DOWNER'S GROVE SUBDIVISION, UNIT 3

APPLICATION NUMBER 5 DATE August 16, 2018

DETAIL SITE PLAN

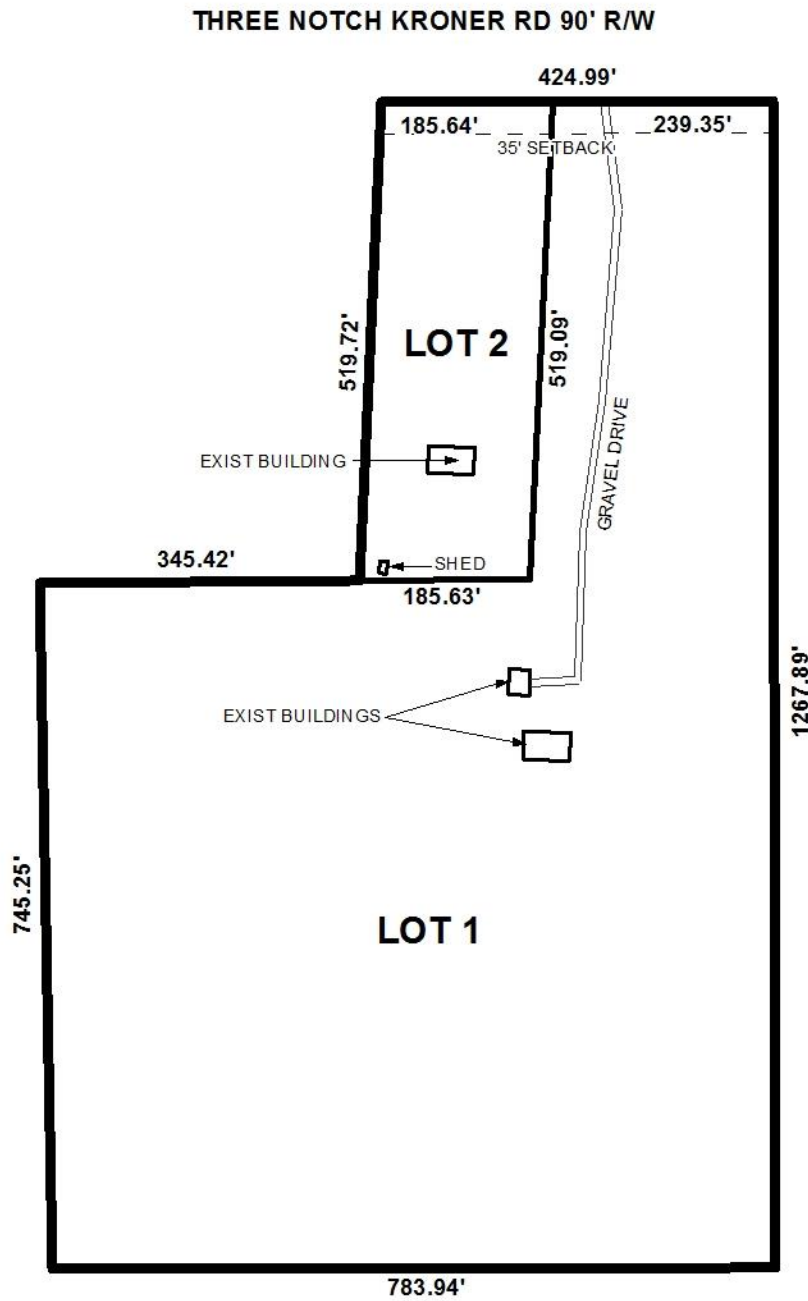
As on the preliminary plat, the recorded 35' minimum building setback line should be retained on the Final Plat. The lot size labels are indicated in both square feet and acres on the preliminary plat and these should be retained on the Final Plat, or a table should be furnished on the Final Plat providing the same information. The proposed lots meet the minimum area requirements of the Subdivision Regulations.

As each lot would retain the same linear street frontage as on the recorded Downer's Grove Subdivision, Unit 2, and as each lot was limited to one curb cut to Three Notch Kroner Road, a note should be required on the Final Plat stating that each lot is limited to one curb cut to Three Notch Kroner Road, with the size, location and design to be approved by Mobile County Engineering and conform to AASHTO standards.

Proposed Lot 1 exceeds the width-to-depth ratio of Section V.D.3. of the Subdivision Regulations. Due to the width-to-depth being previously approved by the Commission, a waiver of Section V.D.3. may be appropriate.

RECOMMENDATION With a waiver of Section V.D.3., the plat meets the minimum requirements of the Subdivision Regulations and is recommended for Tentative Approval, subject to the following conditions:

- 1) retention of the 35' minimum building setback line along Three Notch Kroner Road on the Final Plat;
- 2) retention of the lot size labels in both square feet and acres on the Final Plat, or the furnishing of a table on the Final Plat providing the same information;

- 3) placement of a note on the Final Plat stating that each lot is limited to one curb cut to Three Notch Kroner Road, with the size, location and design to be approved by Mobile County Engineering and conform to AASHTO standards;

- 4) placement of a note on the Final Plat stating that any lots which are developed commercially and adjoin residentially developed property must provide a buffer, in compliance with Section V.A.8. of the Subdivision Regulations;

- 5) placement of a note on the Final Plat stating that the site must comply with the storm water detention and drainage facility requirements of the City of Mobile storm water and flood control ordinances, and requiring submission of certification from a licensed engineer certifying that the design complies with the storm water detention and drainage facility requirements of the City of Mobile storm water and flood control ordinances prior to the issuance of any permits. Certification is to be submitted to the Planning and Zoning Department and County Engineering; and
